Report on Review of Bay Delta Conservation Program Modeling

Since December 2012, MBK Engineers and Dan Steiner (collectively “Reviewers”) have assisted various parties in evaluating the operations modeling that was performed for the Bay Delta Conservation Plan (BDCP). To assist in understanding BDCP and the potential implications, stakeholders¹ requested that the Reviewers review the CalSim II modeling studies performed as part of the BDCP (hereafter “BDCP Studies” or “BDCP Model”).

Figure 1. Projected Inflow to Trinity, Shasta, Oroville, and Folsom Reservoirs – NAA, NAA-ELT and NAA-LLT

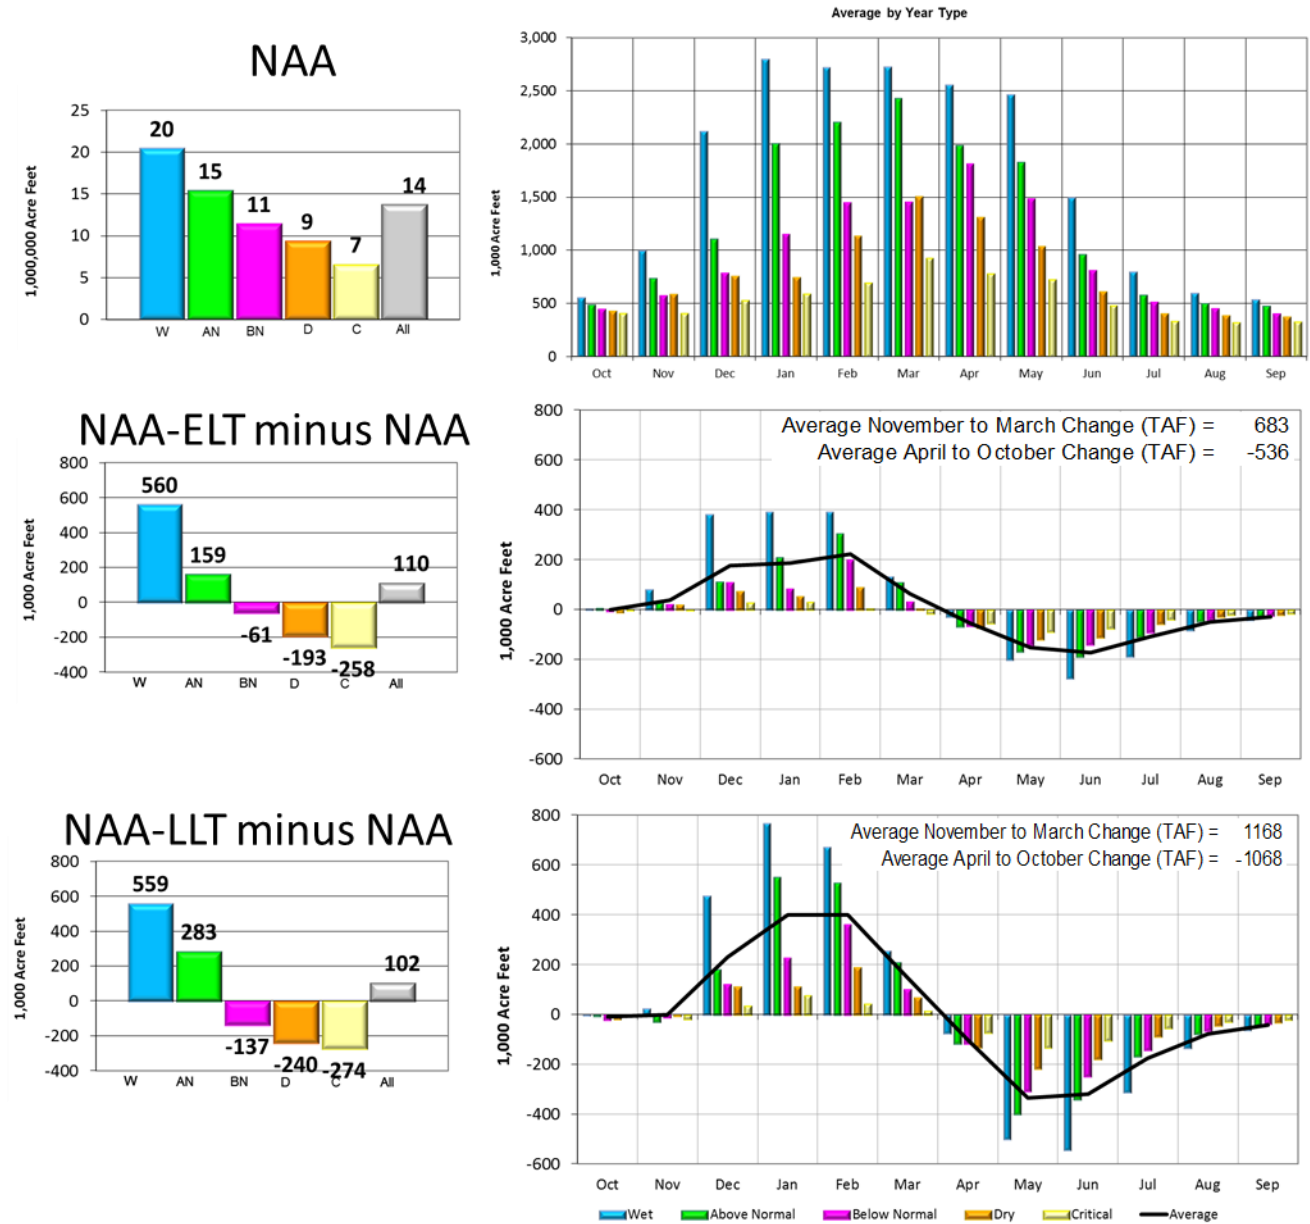
The significance of changed hydrology between the three without project baselines is illustrated in Figure 1 below. The figure illustrates the projected combined inflow of Trinity, Shasta, Oroville, and Folsom Reservoirs under the three NAA baselines. Numerous modeling projections for climate change have been developed, and in this BDCP group of Scenarios Trinity, Shasta, and Oroville inflow are projected to increase overall, but with a

In our opinion, the CalSim II depicted operations that incorporate climate change are not reasonably foreseeable and do not represent a likely future operation of the CVP/SWP. Although an argument is typically made that these study baselines will be used in a comparison analysis with Project Alternatives tiering from these baselines, we believe that the depicted operations do not represent credible CVP/SWP operations and we have no confidence in the results and they are inappropriate as the foundation of a Project Alternative. As such, although the modeling approach may provide a relative comparison between equal foundational operations, we are apprehensive to place much confidence in the computed differences shown between the NAA and Project Alternative Scenarios.

Figure 2. Projected Shasta Reservoir Carryover Storage, NAA, NAA-ELT and NAA-LLT

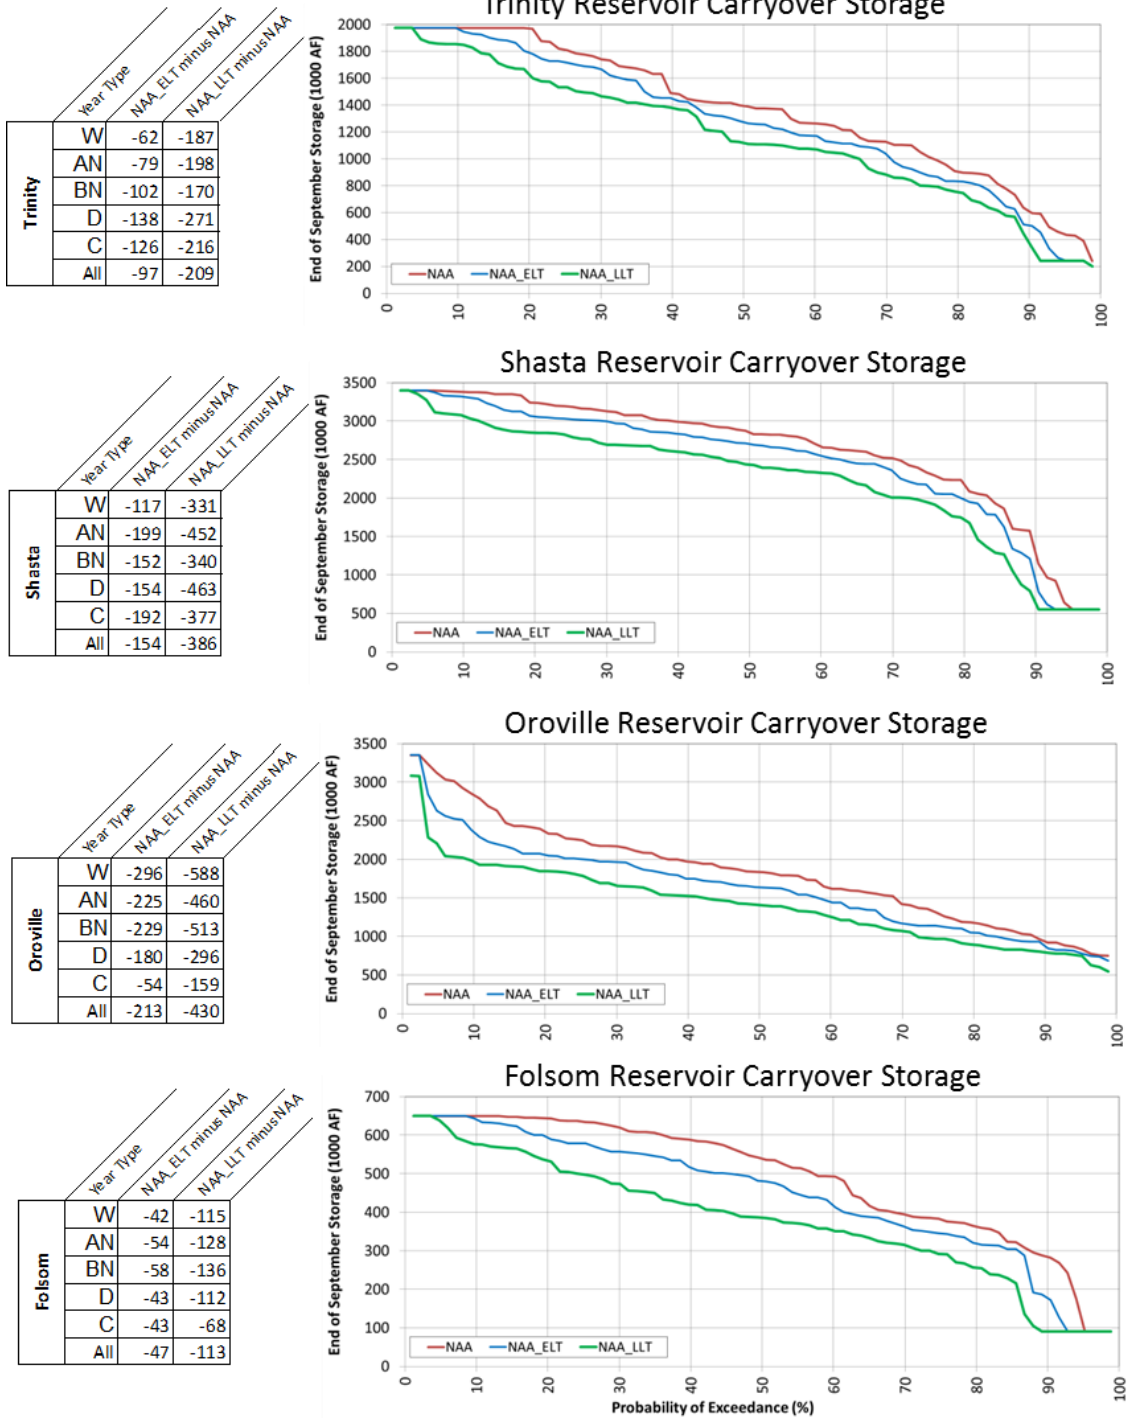
For upstream CVP and SWP reservoirs the assumed shift of inflows due to climate change (Figure 1) along with a continuing need to satisfy exports demands significantly affects carryover storage. The CVP and SWP simply cannot satisfy water demands and regulatory criteria imposed on them in the NAA-ELT and NAA-LLT modeling scenarios.

Figure 2 illustrates the typical change in carryover storage as shown for Trinity, Shasta, Oroville, and Folsom Reservoirs. The relatively high frequency (approximately 10% of time) of minimum storage occurring at CVP reservoirs illustrates our questioning of credible operations in the studies.

Figure 3. Projected Inflow to Millerton Lake –NAA, NAA-ELT and NAA-LLT

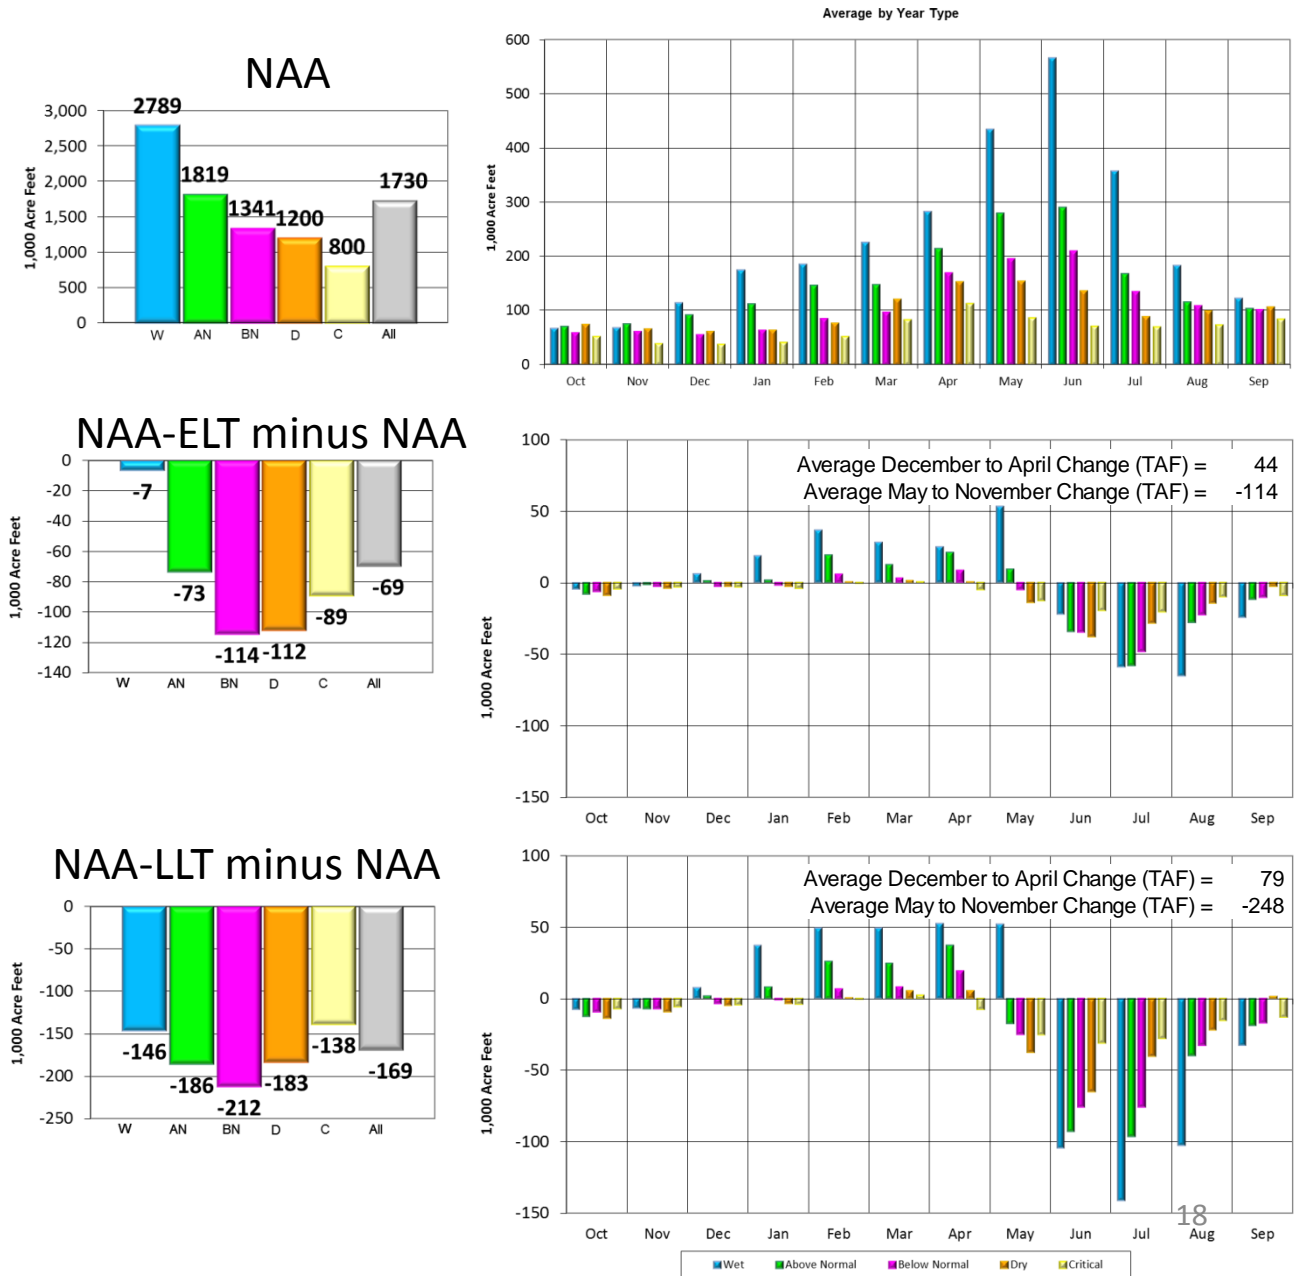
San Joaquin Valley reservoirs are depicted with an overall decrease in annual runoff with some shifting of runoff from spring to winter, but mostly just decreases in spring runoff due to a decline in snowmelt runoff during late spring⁵. Figure 3 illustrates the assumed effects of climate change upon inflow to Millerton Lake.

The hydrology differences imposed in the NAA Scenarios of the Friant Division are described above, and its appropriateness may be subject to additional debate and Alternative assumptions. However, our review found that implementation of Millerton Reservoir inflow as affected by climate change was improperly performed.

Inflow to Millerton Reservoir in this version of CalSim is input in three separate time series for purposes of depicting the hydrology of potential upper basin reservoirs. Climate change hydrology was inconsistently incorporated at Millerton Reservoir and misapplied to the water supply and flood control operations. The result is an unrealistic operation for river releases and canal diversions. Figure 3 illustrates the projected ELT and LLT changes in Millerton Reservoir inflow incorporated in these studies. On face value of the input data, regardless of Friant Dam river release assumptions the effect of climate change at Millerton Lake will affect water deliveries.

Figure 4. Millerton Reservoir Carryover Storage, NAA, NAA-ELT and NAA-LLT Scenarios

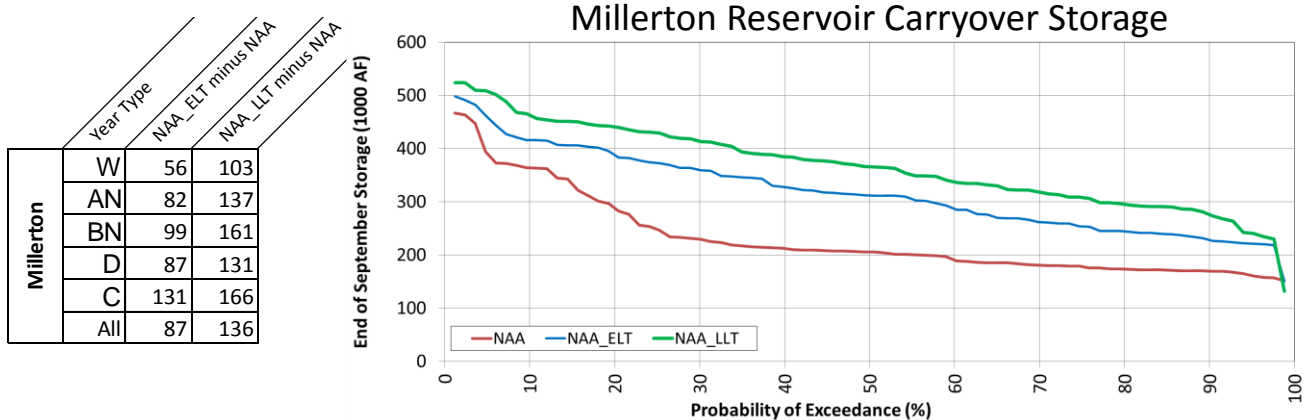
Evidence of the inconsistent inflow problem is shown in the result for the comparison of carryover storage of Millerton Reservoir under the NAA, NAA-ELT, and NAA-LLT Scenarios (Figure 4). Carryover storage is higher in the ELT and LLT Scenarios due to climate change effects to inflow incorporated in reservoir operations but not in the computation of water supply deliveries. Thus, water deliveries are suppressed and the reservoir ends the year with greater storage.

Figure 12. Temperature Exceedance Sacramento River at Bend Bridge Existing, No Action Alternative, ELT

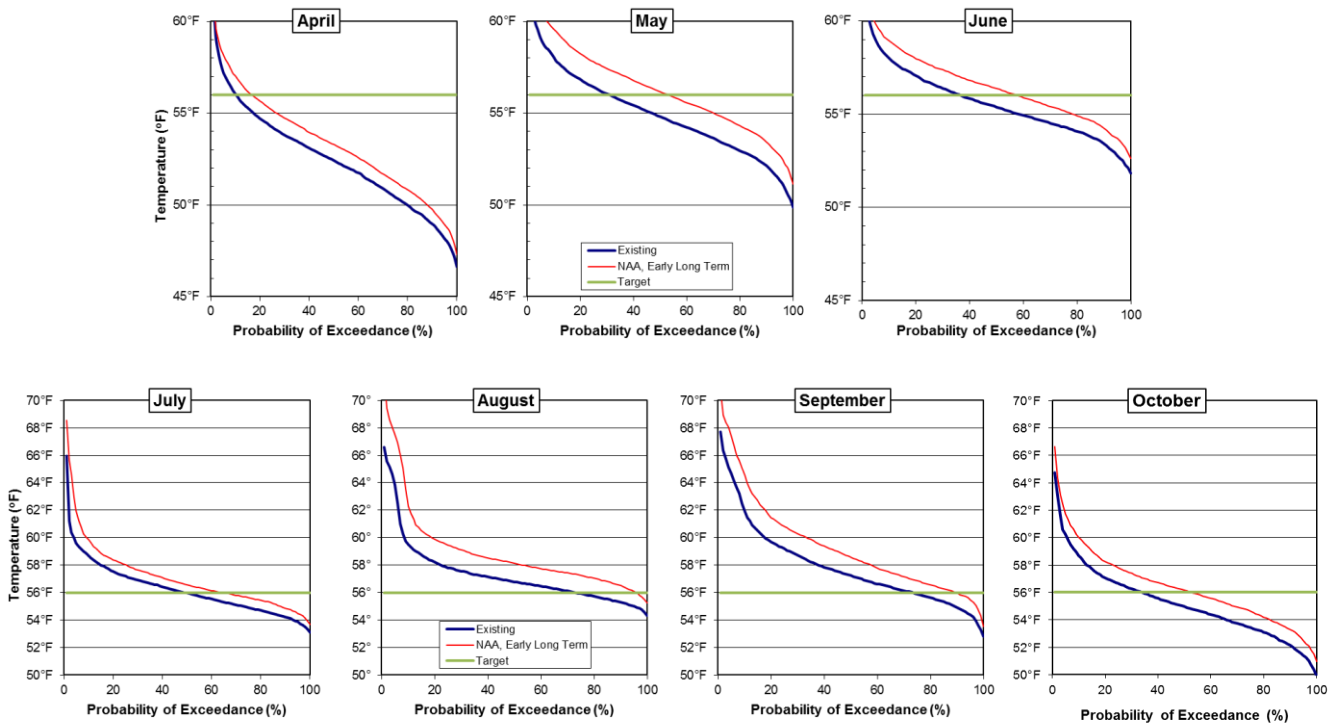
The increase in equilibrium temperatures combined with decreases in storage would lead to water temperature conditions that would likely not achieve the assumed objectives. Figure 12 and Figure 13 illustrate an increase in the probability that a water temperature target of 56°F would be exceeded at Bend Bridge under both the NAA-ELT and NAA-LLT Scenarios. The probability of exceedance increases approximately 5% to 20% depending on the month for the NAA-ELT Scenario and approximately 10% to 40% for the NAA-LLT Scenario.

Figure 19. NDD, Bypass Requirement, Bypass Flow, and Excess Sacramento R. flow for Alt 4-ELT

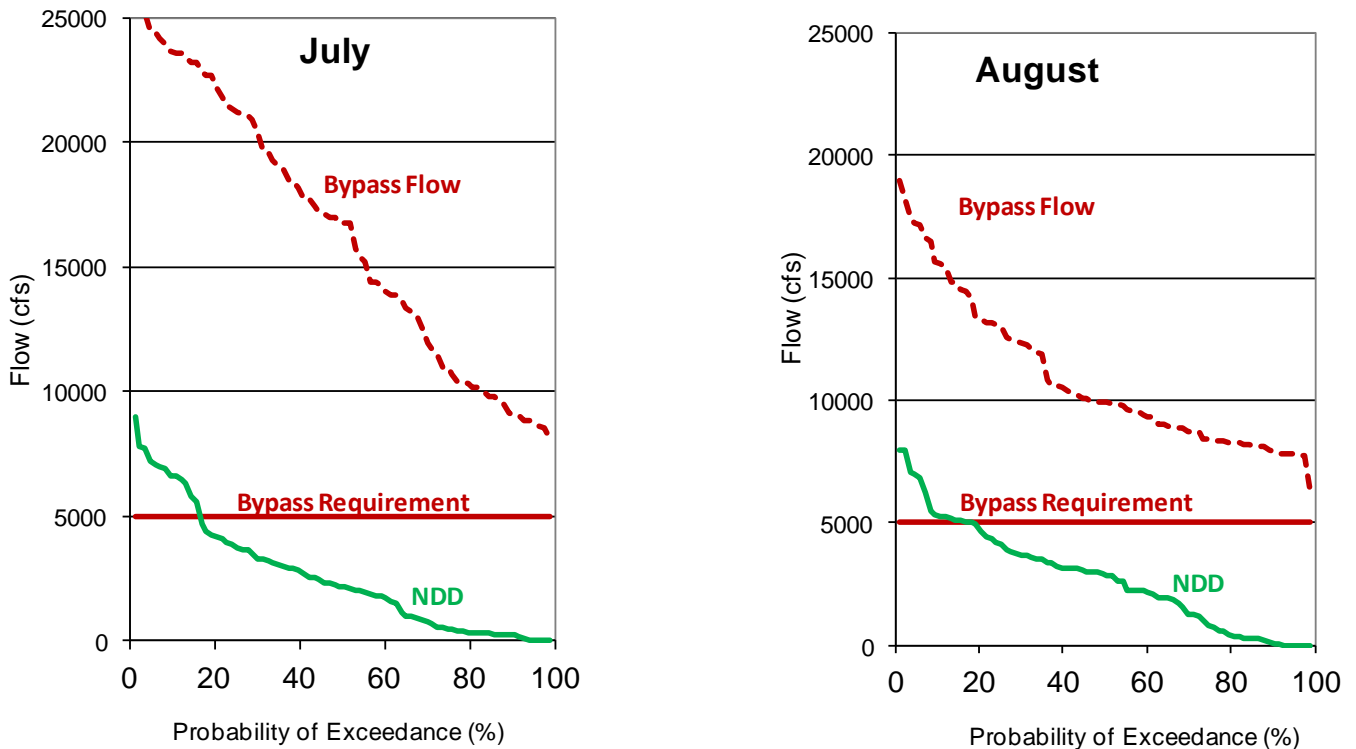
Sacramento River flow below the North Delta Diversion (NDD) must be maintained above the specified bypass flow requirement, therefore the NDD rates are limited to the Sacramento River flow above the bypass requirement. Due to an error in CalSim II that specifies an unintended additional bypass requirement, modeling performed for the BDCP EIRS often bypasses more Sacramento River flow than is specified in the BDCP project description. This error has been fixed in the most recent public releases of CalSim II, but BDCP modeling has not been updated to reflect these fixes. Figure 19 contains exceedance probability plots showing the Sacramento River required bypass, Sacramento River bypass flow, NDD, and excess Sacramento River flow to the Delta as modeling for BDCP. As can be seen in Figure 19, the bypass flow is always above the bypass requirement in July and August. The BDCP version of CalSim sets a requirement for Sacramento River inflow to the Delta needed to satisfy all Delta flow, quality, and export requirements, this requirement should be removed when modeling the NDD.

Figure 22. Alt 4-ELT North Delta Diversion Versus South Delta Diversion for July, August, and September

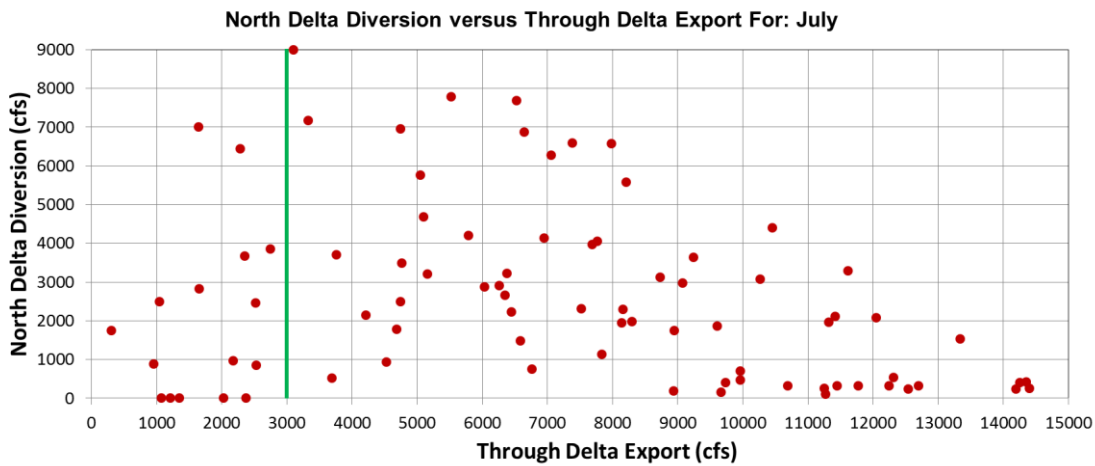
Figure 22 contains figures for July, August, and September for Alt 4-ELT that plot NDD against SDD. In the months of July to September SDD are occasionally very high, exceeding 14,000 cfs in July, with minimal NDD. This occurs due to outdated model code that imposes an instream flow requirement in Sacramento River flow below Hood in excess of the bypass criteria prescribed in the BDCP. There are numerous occurrences when bypass flows prescribed in the BDCP are exceeded and SDD are higher than expected. On the other hand, there are also many times when NDD are above minimum pumping levels and SDD are below the BDCP prescribed 3,000 cfs threshold indicated by the green line in Figure 22. For unknown reasons, the model code requiring SDD to be greater than 3,000 cfs before NDDs occur from July through September is deactivated in the BDCP modeling of this Alternative.

Figure 23. South Delta Diversion at Banks

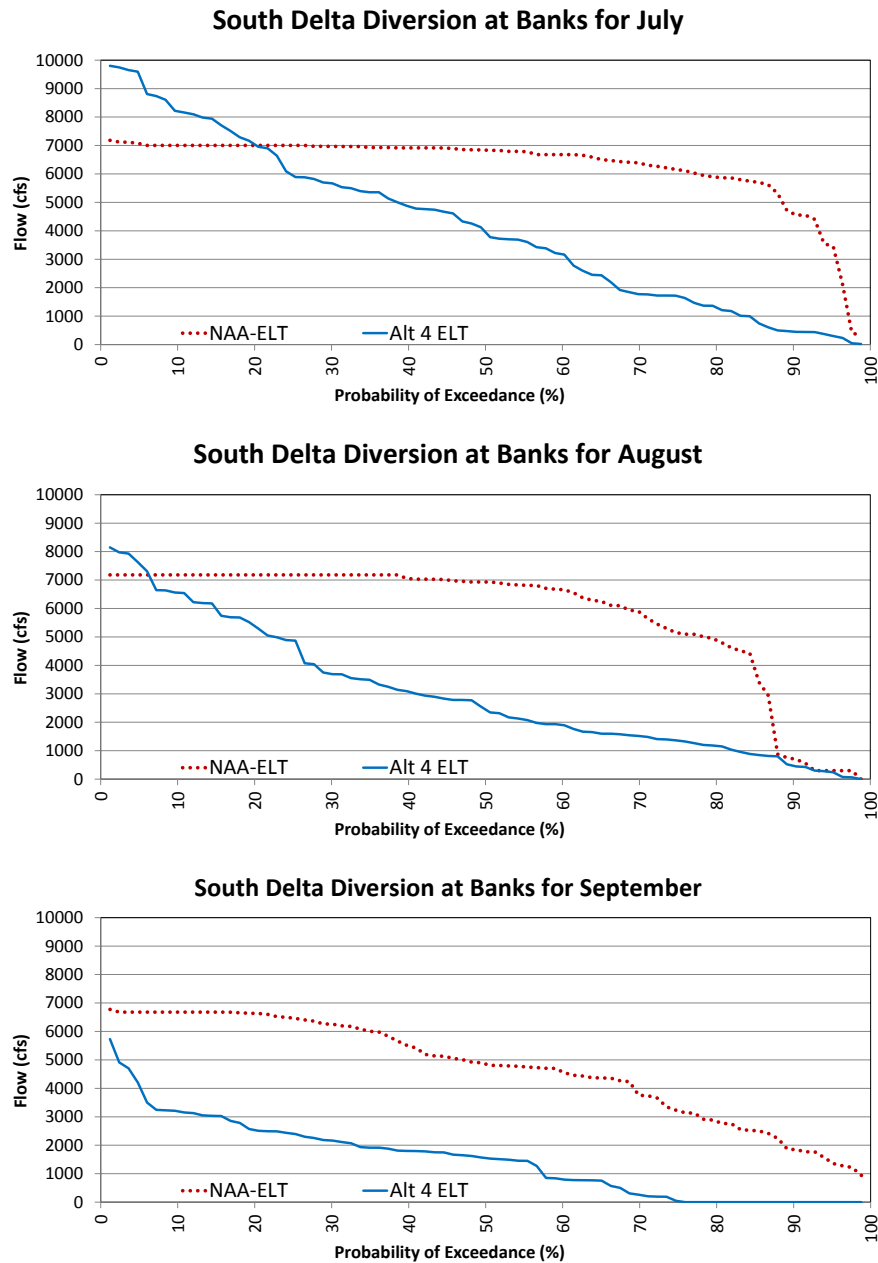
South Delta Diversion at Banks is not limited to existing permit capacity of 6,680 cfs and pumping may reach full capacity of 10,300 cfs in July, August, and September. Figure 23 contains exceedance probability charts of South Delta Diversion at Banks for July, August, and September. The chart for July shows SDD at Banks exceeding existing permit capacity 20% of years, in August this occurs in about 7% of years. There are South Delta diversions at Banks 25% of the time in September while diversions from the Sacramento River may range from 2,500 cfs to 7,500 cfs.
